## ATTACHMENT B

### Summary of Revised Pages

Proposed changes to Appendix A, Technical Specifications of Facility Operating License NPF-72 and NPF-77, Byron Station.

Proposed changes to Appendix A, Technical Specifications of Facility Operating License NPF-72 and NPF-77, Braidwood Station.

FIGURE 4.7-1  
 (THIS FIGURE NOT USED)  
 SAMPLE PLAN 2) FOR SNUBBER FUNCTIONAL TEST

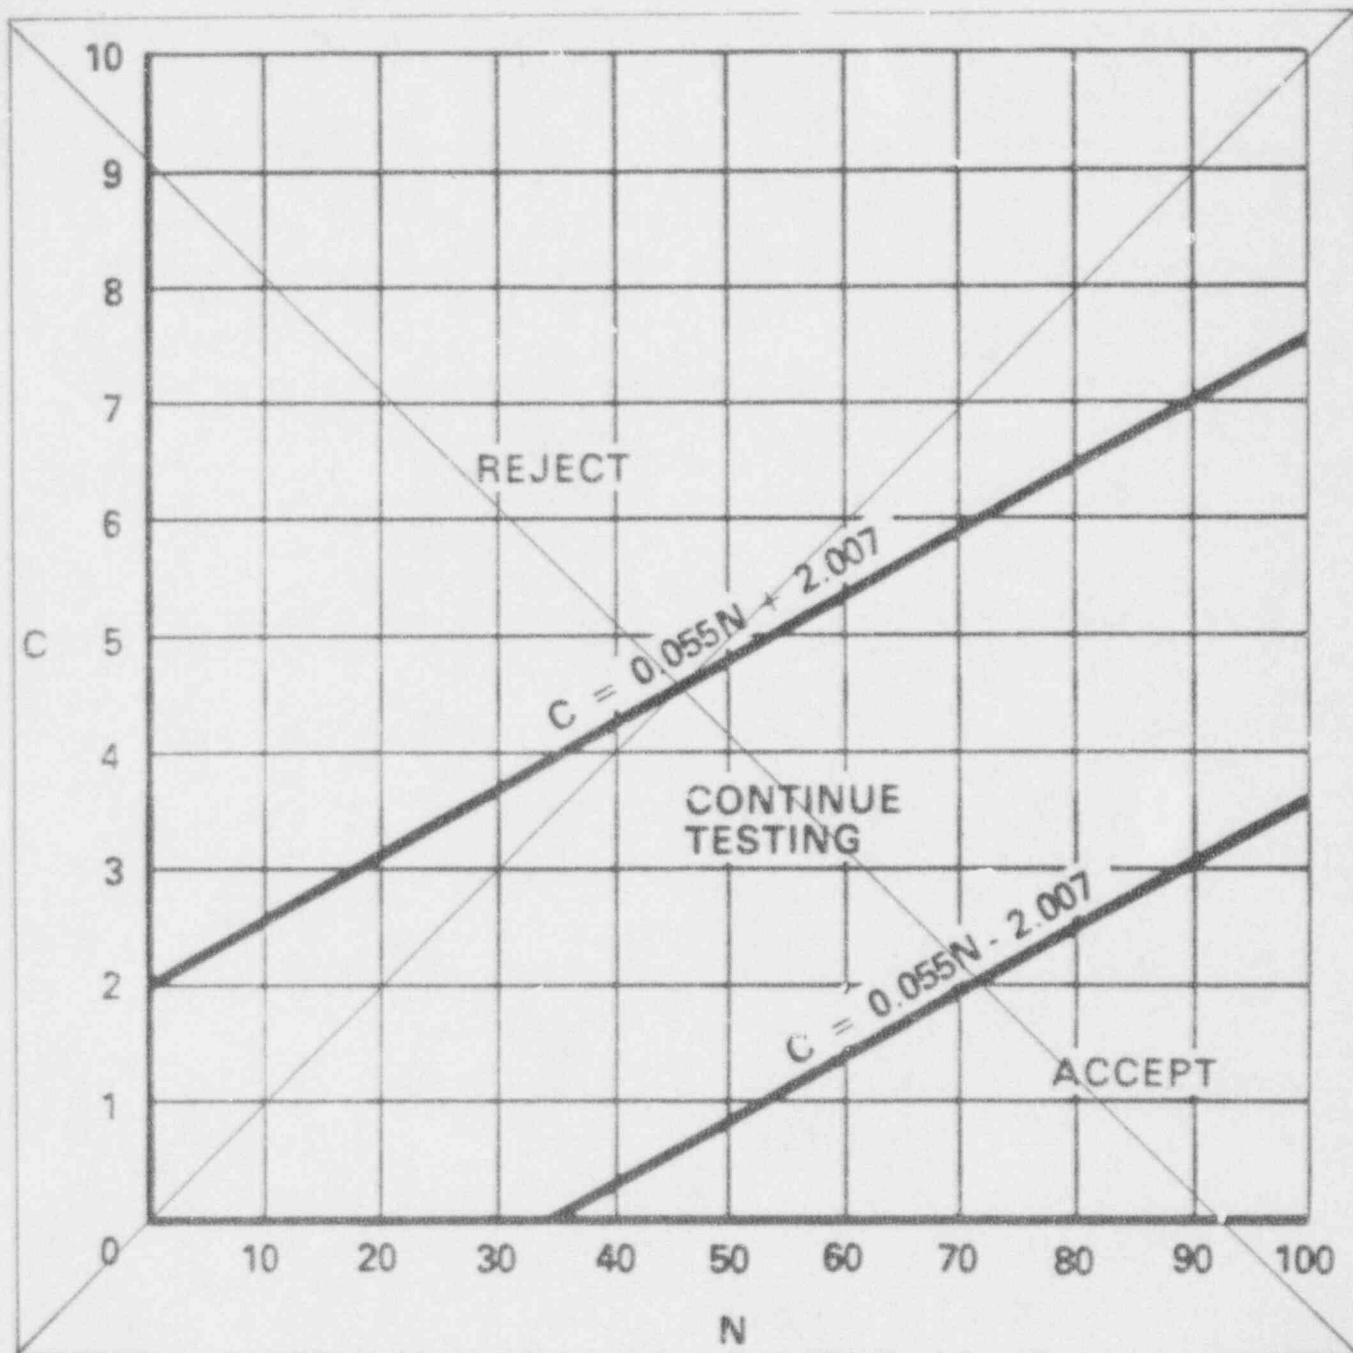
FIGURE 4.7-1 <sup>THIS FIGURE NOT USED</sup> ~~SAMPLE PLAN 2) FOR SNUBBER FUNCTIONAL TEST.....~~ 3/4 7-27

~~Figure 4.7-1 was developed using "Wald's Sequential Probability Ratio Plan" as described in "Quality Control and Industrial Statistics" by Acheson J. Duncan.~~

FIGURE 4.7-1

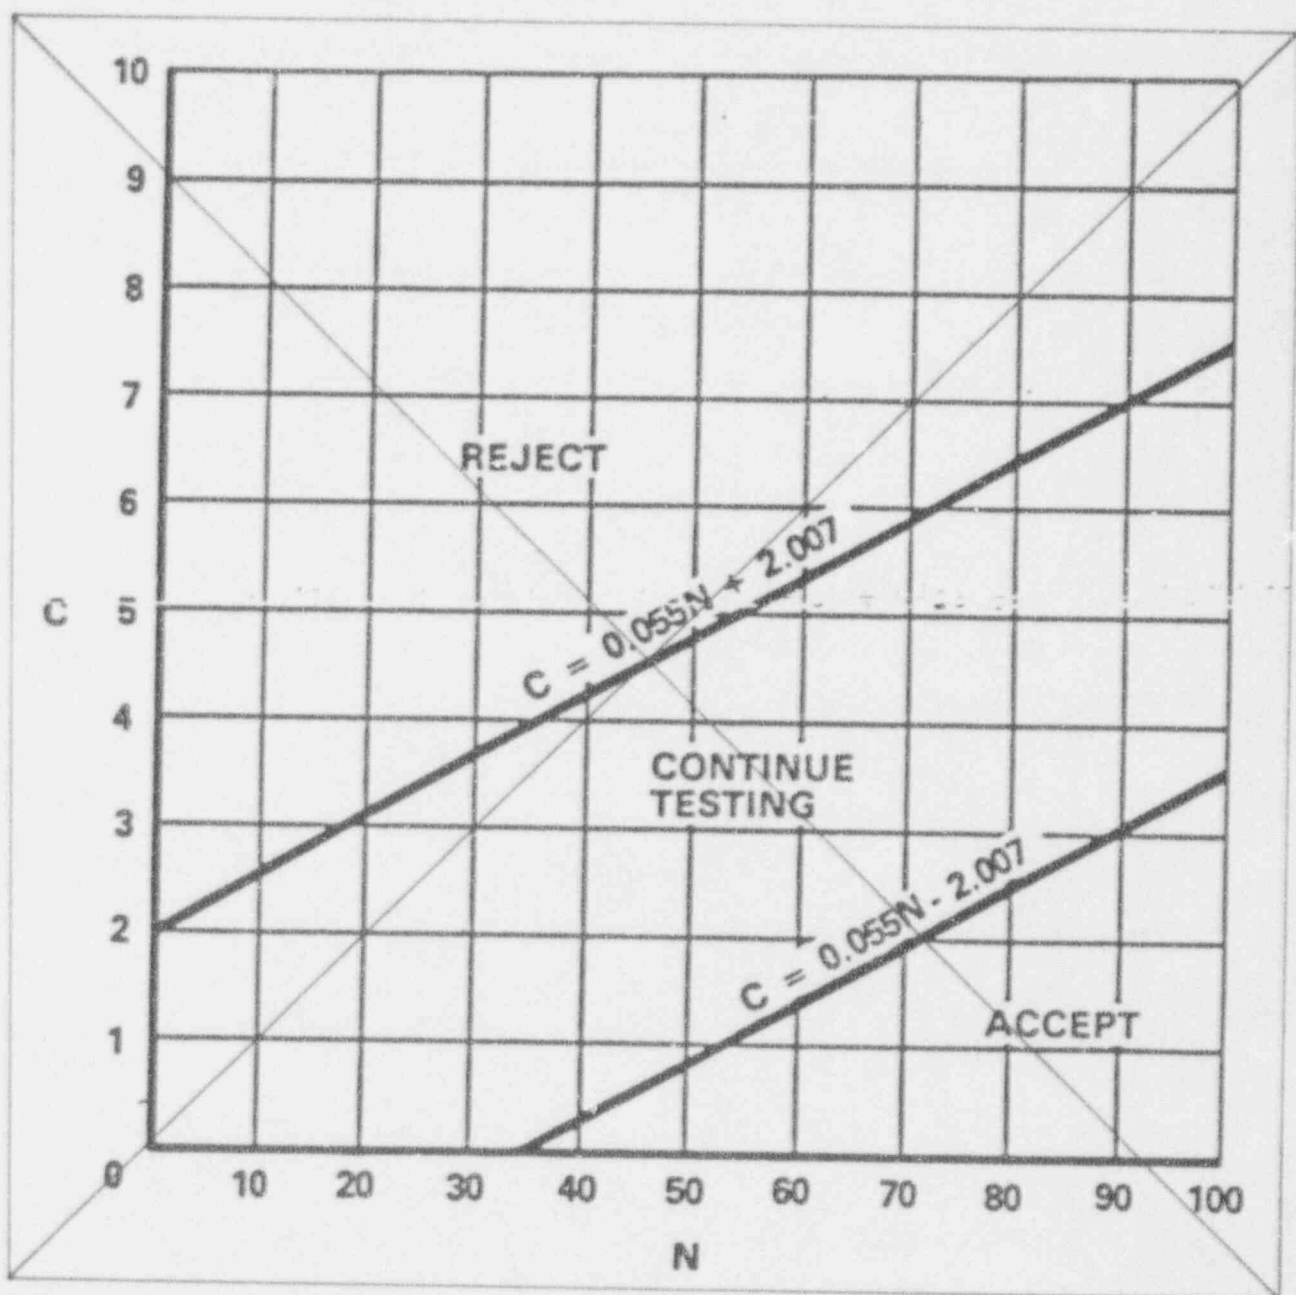
##### FIGURE 4.7-1 ~~SAMPLE PLAN 2) FOR SNUBBER FUNCTIONAL TEST~~..... 3/4 7-25

~~SAMPLE PLAN 2) FOR SNUBBER FUNCTIONAL TEST~~  
 (THIS FIGURE NOT USED)

~~Figure 4.7-1 was developed using "Wald's Sequential Probability Ratio Plan" as described in "Quality Control and Industrial Statistics" by Acheson J. Duncan.~~
